IEEE 802.16 Broadband Wireless Access Working Group < http://ieee802.org/16 >	
	Harmonized proposal to replace traffic models in IEEE 802.16j-06/013	
Date Submitted	2006-09-28	
Source(s)	<p>Wendy C Wong wendy.c.wong@intel.com Roshni Srinivasan Hannah Hyunjeong Lee Kerstin Johnsson Jerry Sydir Sassan Ahmadi Belal Hamzeh Shailender Timiri Intel Corporation 2200 Mission College Blvd., Santa Clara, CA 95054, USA.</p> <p>I-Kang Fu IKFu@itri.org.tw National Chiao Tung University / Industrial Technology Research Institute 1001 Ta Hsueh Road, Hsinchu , Taiwan 300, ROC.</p> <p>Peter Wang peter.wang@nokia.com Nokia US 6000 Connection Dr Irving, TX 75039, USA.</p> <p>David Chen david.t.chen@motorola.com Hua Xu Roger Peterson Motorola Inc 1441 W. Shure Drive, Arlington Heights, IL 60004 USA.</p> <p>Aik Chindapol aik.chindapol@siemens.com Teck Hu Siemens 755 College Road East, Princeton, NJ 08540</p>	<p>Mike Hart, Sunil Vadgama Mike.Hart@uk.fujitsu.com Fujitsu Laboratories of Europe Ltd. Hayes Park Central Hayes End, Middx., UB4 8FE, UK.</p> <p>Peng-Yong Kong, Haiguang Wang kongpy@i2r.a-star.edu.sg Institute for Infocomm Research 21 Heng Mui Keng Terrace Singapore 119613</p> <p>Dharma Bageet, Y

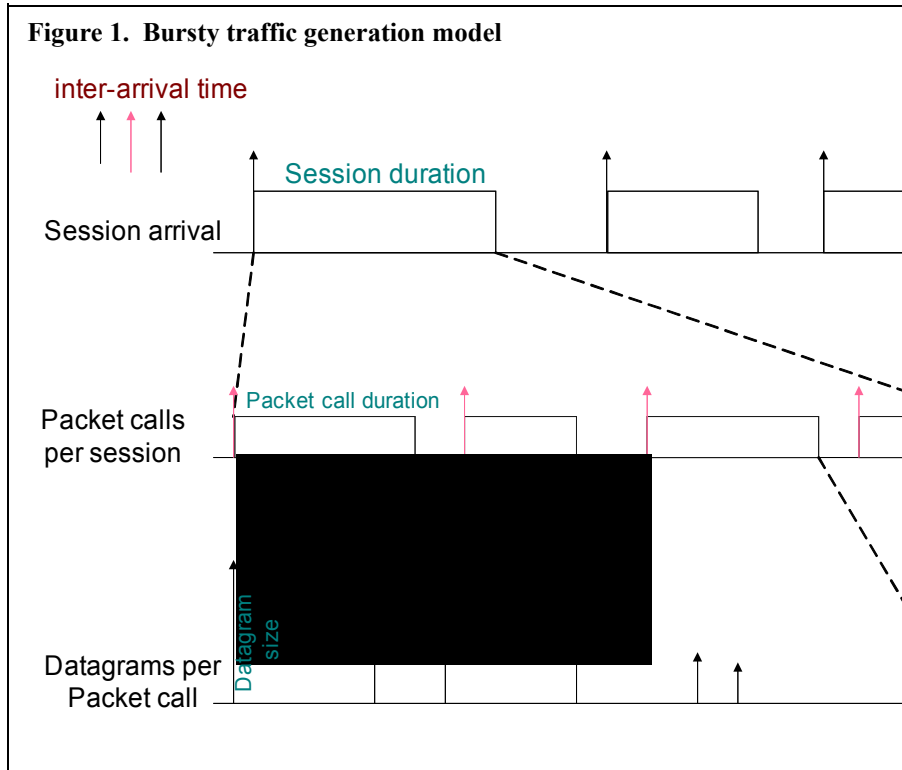
[Editor's note: Insert the following text and Figure 1. The first paragraph summarizes the Appendix C.3.3]

The FTP and HTTP traffic models listed in Table 1 can be generated using the bursty traffic generation model described in Figure 1. For each traffic source, the following characteristics are modeled:
